Development Review Staff Report

Administrative Hearing: July 24, 2023

College and Trilby Multifamily #PDP220009

1. Modification of a Standard for Building Variation -- 3.5.2(C)

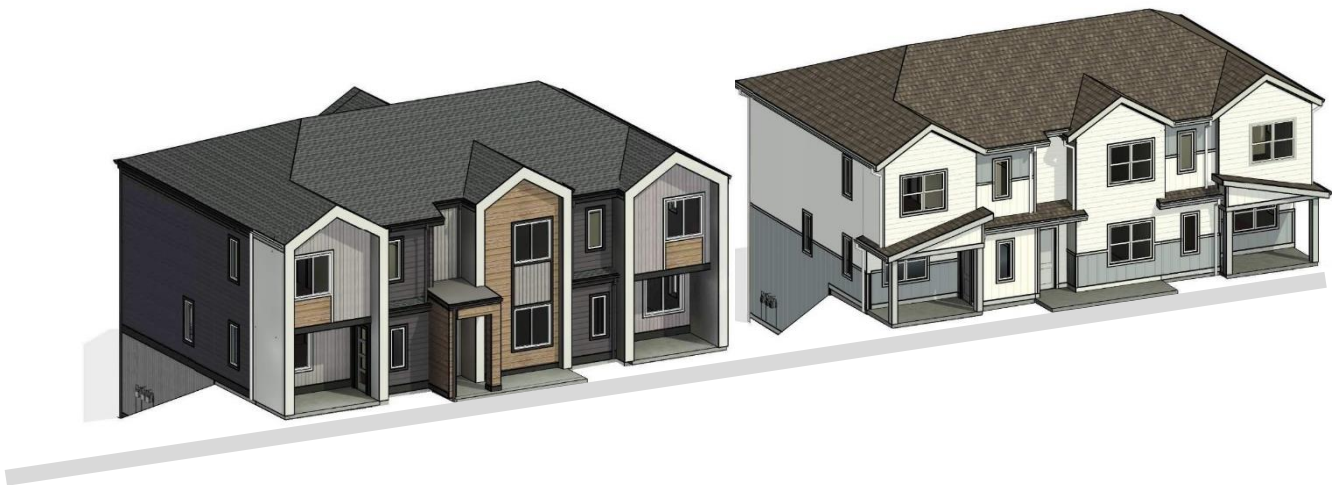
This standard for single-family attached dwellings (townhomes) requires variation among repeated buildings that have more than two units. At least 3 distinctly different building designs are required for the 3- and 4-unit buildings in this plan. This includes a requirement that the different designs must “vary significantly in footprint size and shape”; and no similar buildings may be placed next to each other.

This modification request is needed because 3- and 4-unit buildings with the same footprints are placed next to each other in numerous instances throughout the plan.

Staff finds that the modification of this standard would not be detrimental to the public good and that the request satisfies criteria (1) and (4) in subsection 2.8.2(H) – “equal or better” and “nominal and inconsequential when considered from the perspective of the whole plan.”

- The whole plan is for housing at the ‘missing middle’ scale, which is a city planning term for housing alternatives between detached houses and apartment complexes with large buildings and parking lots. The 3- and 4- unit buildings have a similar scale, with lengths of 60 feet and 78 feet, so that the effect of two of the same together is not very different from having one of each next to each other.

2. Modification of a Standard for Street-Facing Facades – 3.5.2(D)(2)

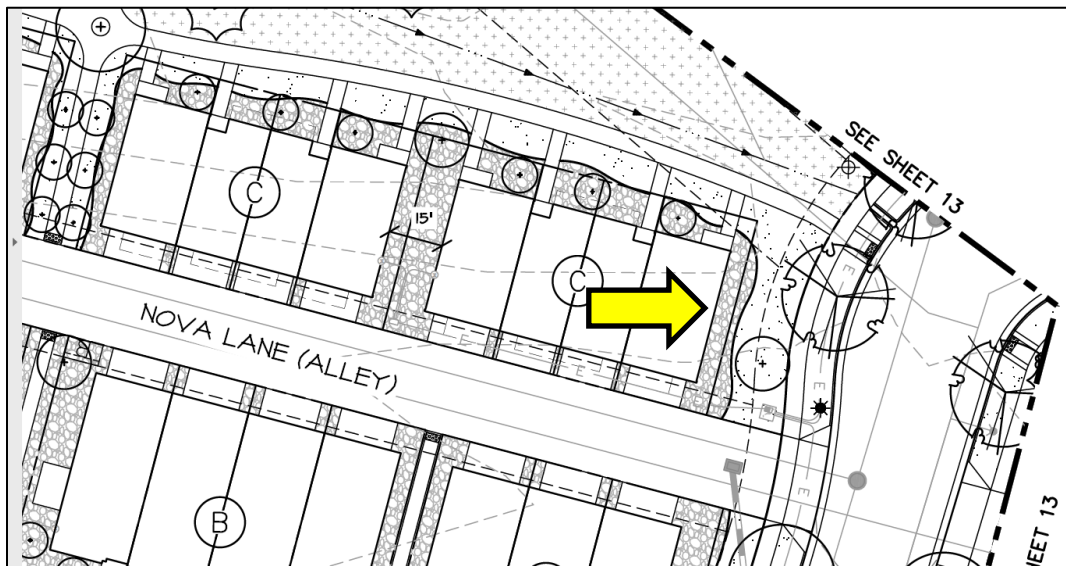
This standard requires that buildings with 4 or more dwelling units must have a doorway facing adjacent neighborhood streets (could be secondary patio doors.) The intent is to avoid impersonal blank ends of multi-unit buildings, often with only utility meters as the most prominent feature, along neighborhood streets. A doorway indicates the presence of people as an animating architectural feature.

One such building has one end facing Rover Drive without a doorway.

This is one such occurrence out of 85 buildings. The interior of the building is a garage partly below grade, with the grade in the outside yard sloping down along the building wall such that a doorway would be non-functional. The visual impact is mitigated by being located on a curve, and by two trees in the foreground closer to the sidewalk.

Staff finds that the granting of the modification would not be detrimental to the public good and that the plan satisfies criteria in subparagraph (4), "nominal and inconsequential" under Section 2.8.2(H) governing modification requests.

The impact of the end wall upon the street is mitigated by its location on a curve where the view is shifting, and a street tree and an ornamental tree with the wall as backdrop.
